LAND USE APPLICATION SUMMARY

Property Location: 2910 - 2936 Pillsbury Avenue South
Project Name: Karmel Plaza and Square
Prepared By: Andrew Liska, City Planner, 612.673.2264
Applicant: Basim Sabri, Karmel Properties, LLC
Project Contact: Scott Nelson, DJR Architecture Inc.
Request: Additions to the 1st, 2nd, 3rd, and 4th floors
Required Applications:

BZZ-7324

5 WEST (PLEASANT) ELEVATION
1/16" = 1'-0"

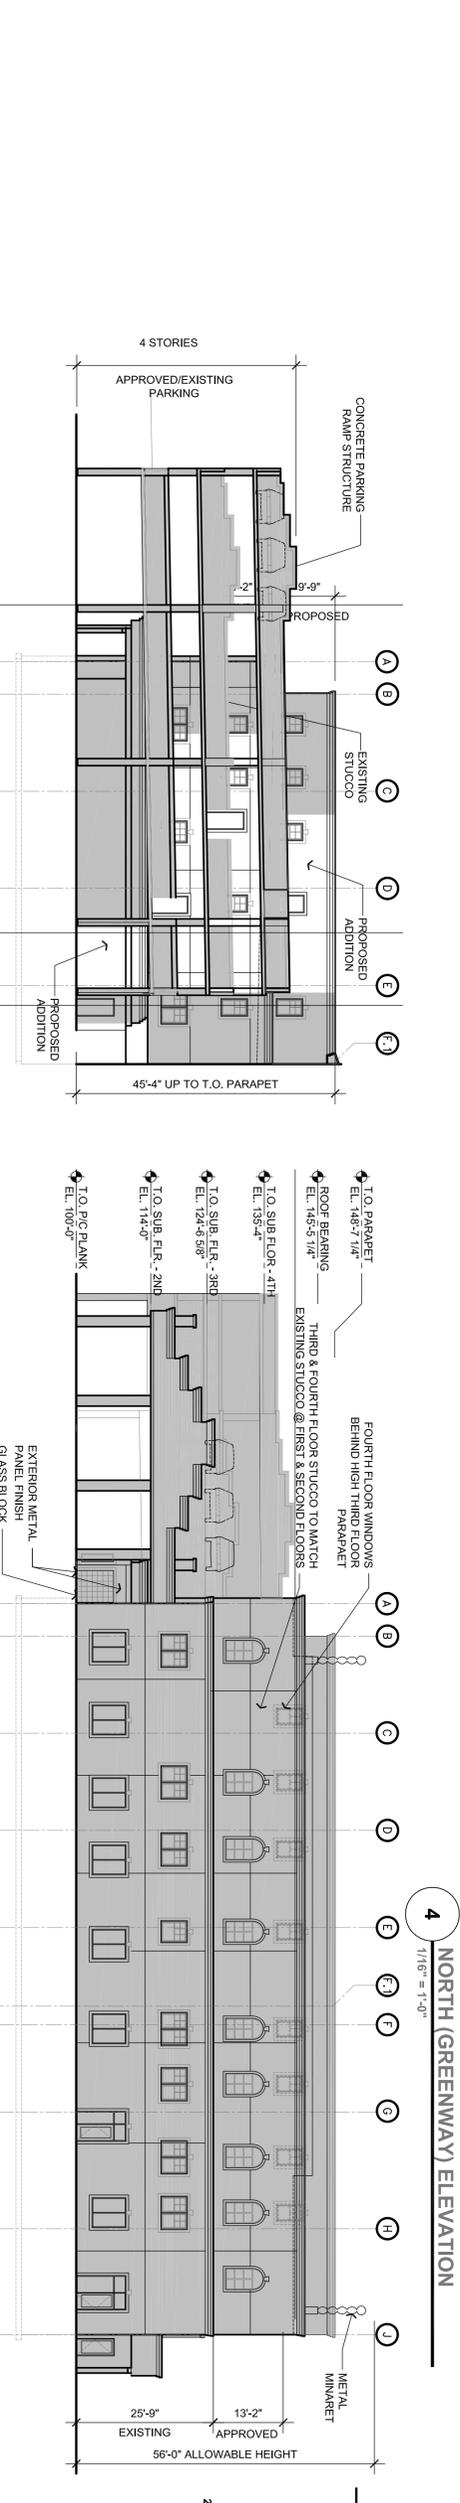
- The applicant will need to add window coverage to the west elevation 3rd floor as the proposal demonstrates 8.9% coverage; 10% coverage is the minimum.

Location	Floor	Code Requirement / Square Footage	Proposed / Square Footage
Midtown Greenway (North)	3	10% minimum 245.6 sq. ft.	11% 271.04 sq. ft.
Pleasant Avenue (West)	3	10% minimum 110.4 sq. ft.	8.9% 98.56 sq. ft.

- **Windows for the 3rd Floor facing Pleasant Avenue:** Alternative compliance is requested for the 3rd floor walls facing Pleasant Avenue. No alternatives are proposed and it is not impractical to meet these requirements therefore staff is recommending that the Planning Commission not grant alternative compliance.

4 NORTH (GREENWAY) ELEVATION
1/16" = 1'-0"

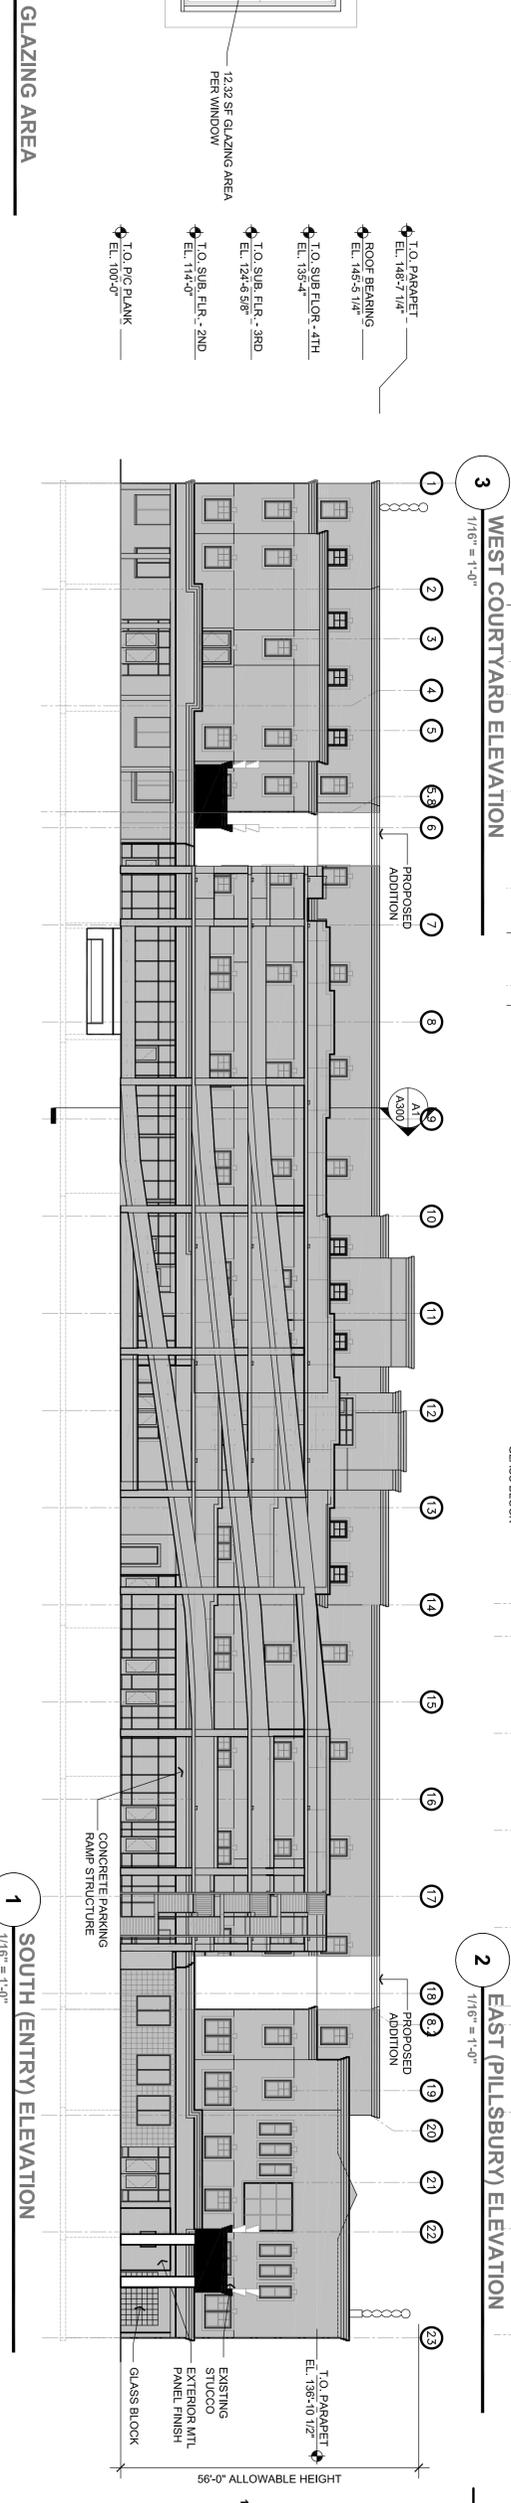
Staff comment: The proposed 3rd floor expansion to the north side of the structure will increase the shadowing on the Midtown Greenway. On page 6 above, the shadowing is analyzed as is a demonstration of other buildings along the south side of the Midtown Greenway relating to height, setbacks, the overall length of the structure and similar findings. The cross-sectional shadow study demonstrates minimal increased shadowing of the Greenway associated with the proposed 3rd floor addition.

1 SECTION THRU GREENWAY - 3RD STORY
 1/8" = 1'-0"

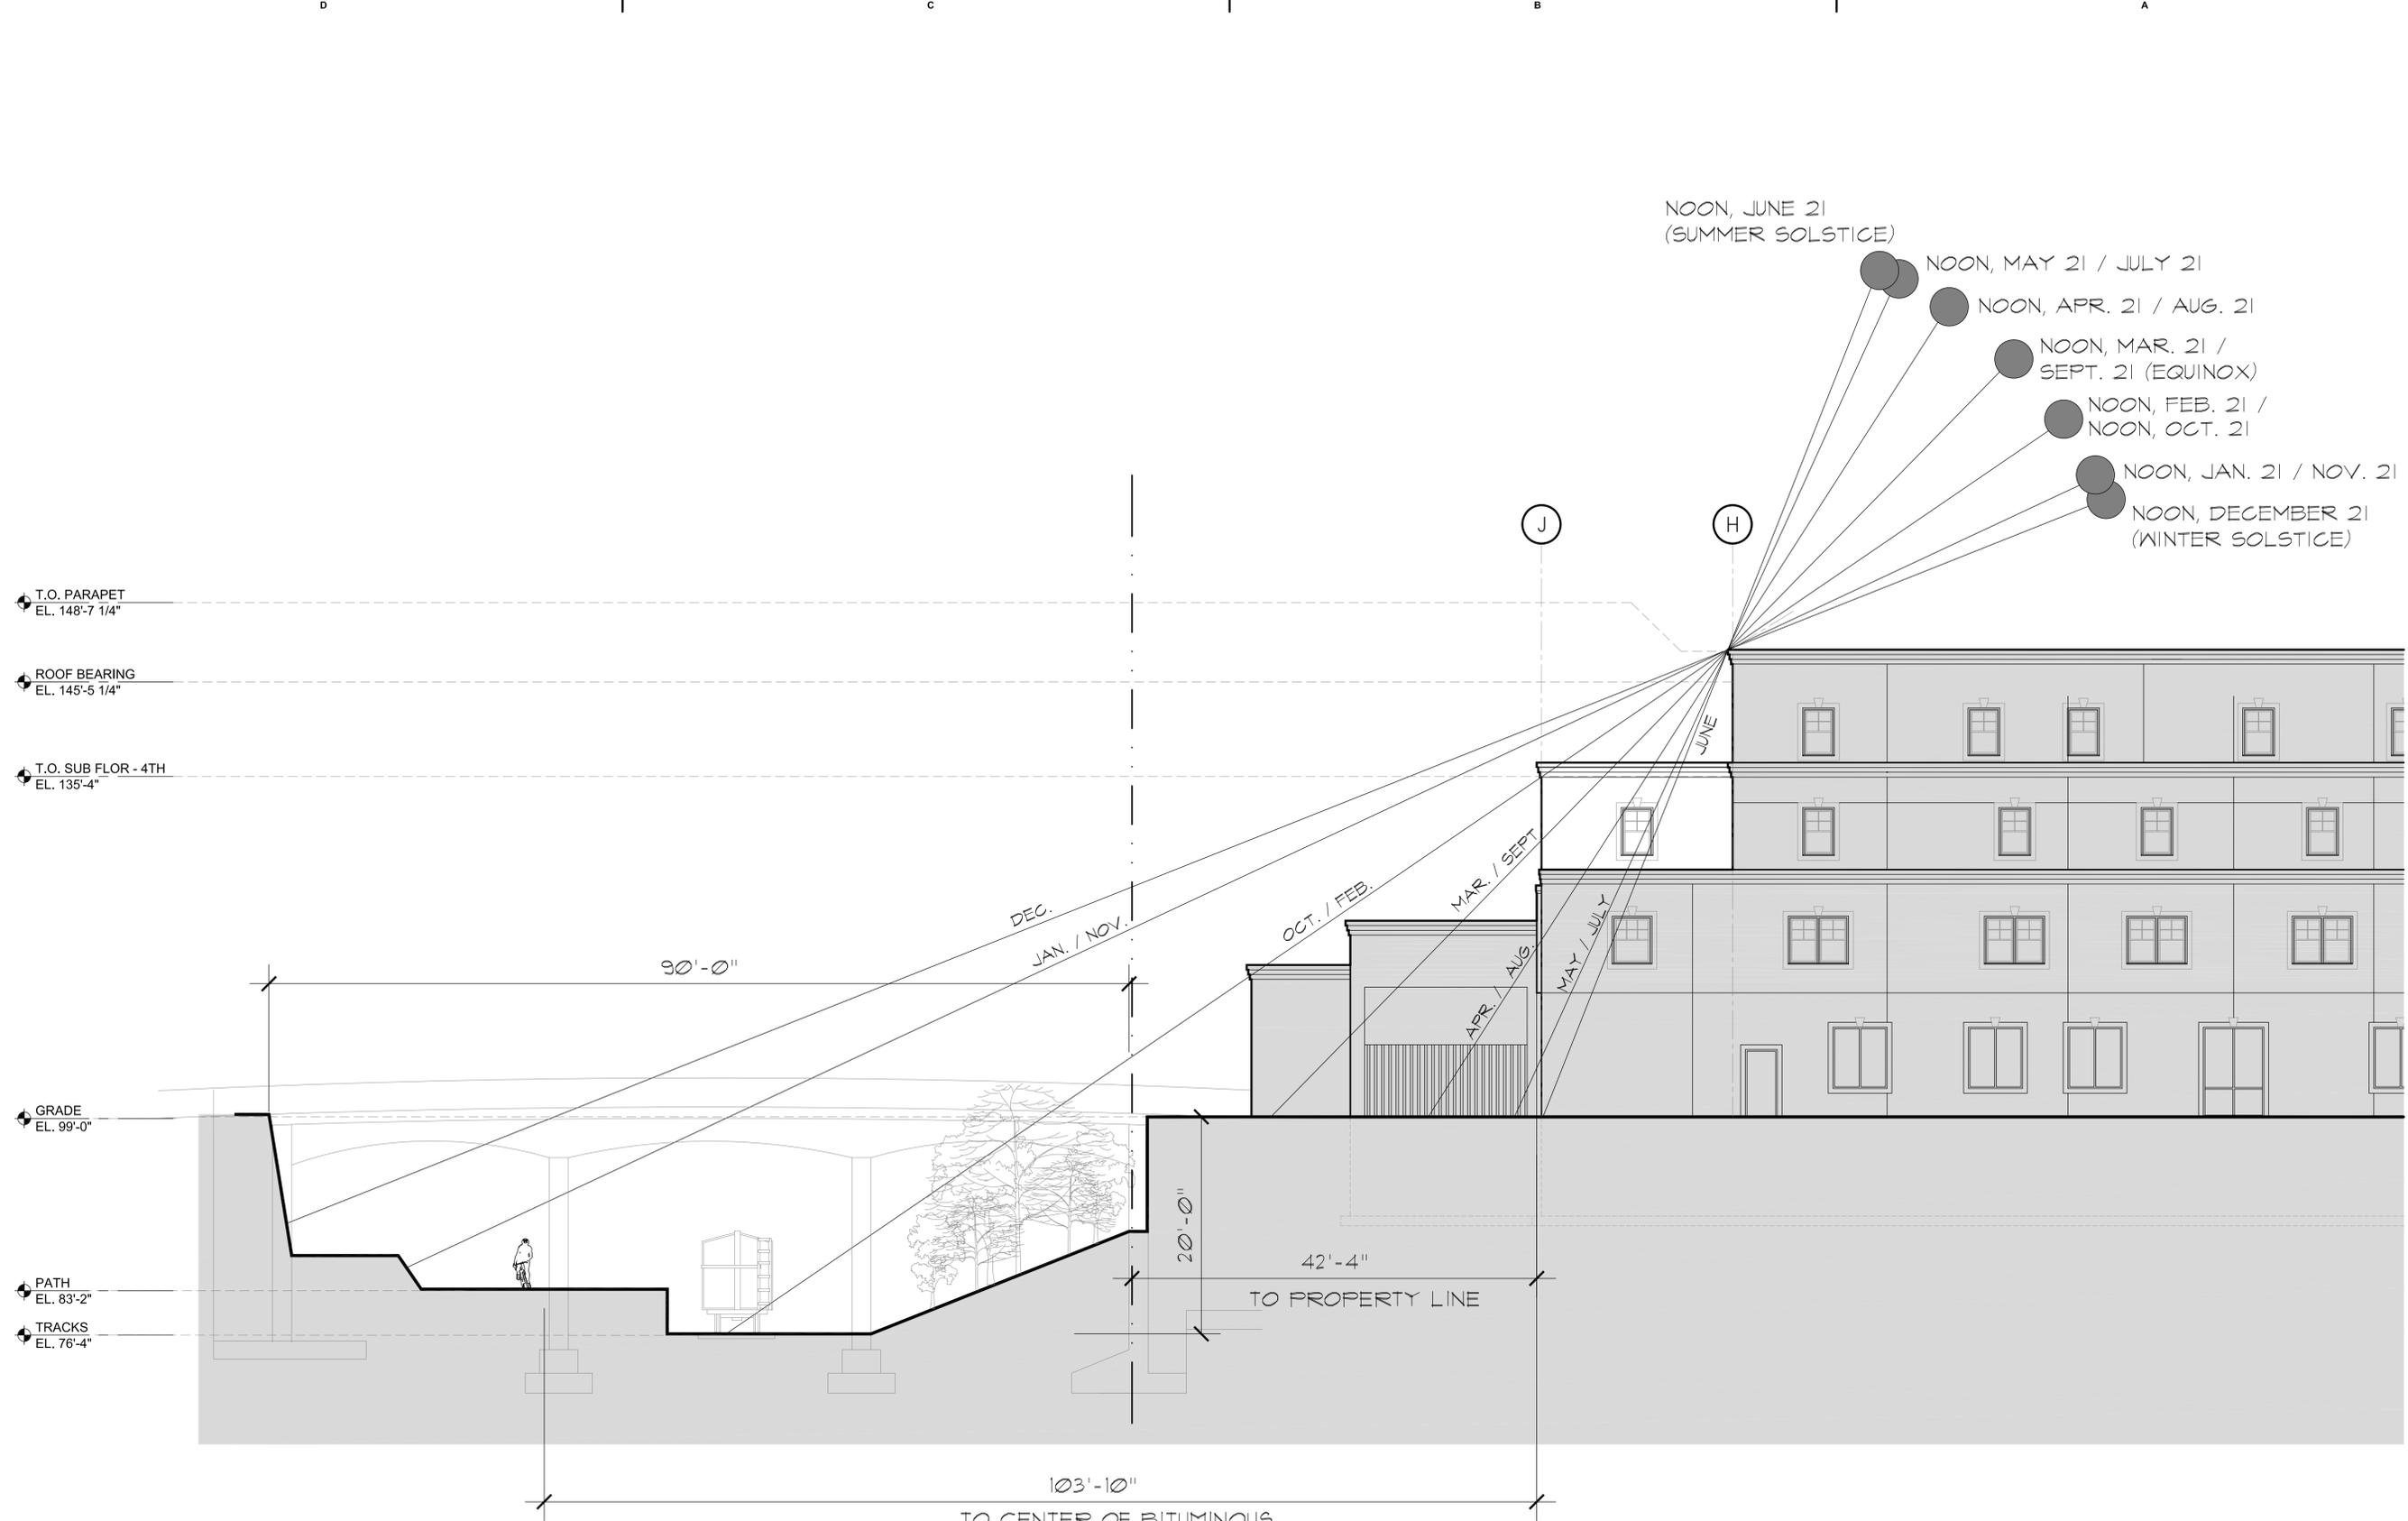
The City Planning Commission approved the construction of the 3rd and 4th stories in 2014 but conditioned that the increased stories of the structure be recessed as to not substantially increase shadowing of the Midtown Greenway. The Commission authorized the easterly 65 feet of the third and fourth floors to align with the second floor, with a setback from the north property line of 42 feet. With this application, the applicant has provided a shadow study of what is permitted today and also what is proposed. In addition, a cross-sectional shadow study has been provided.
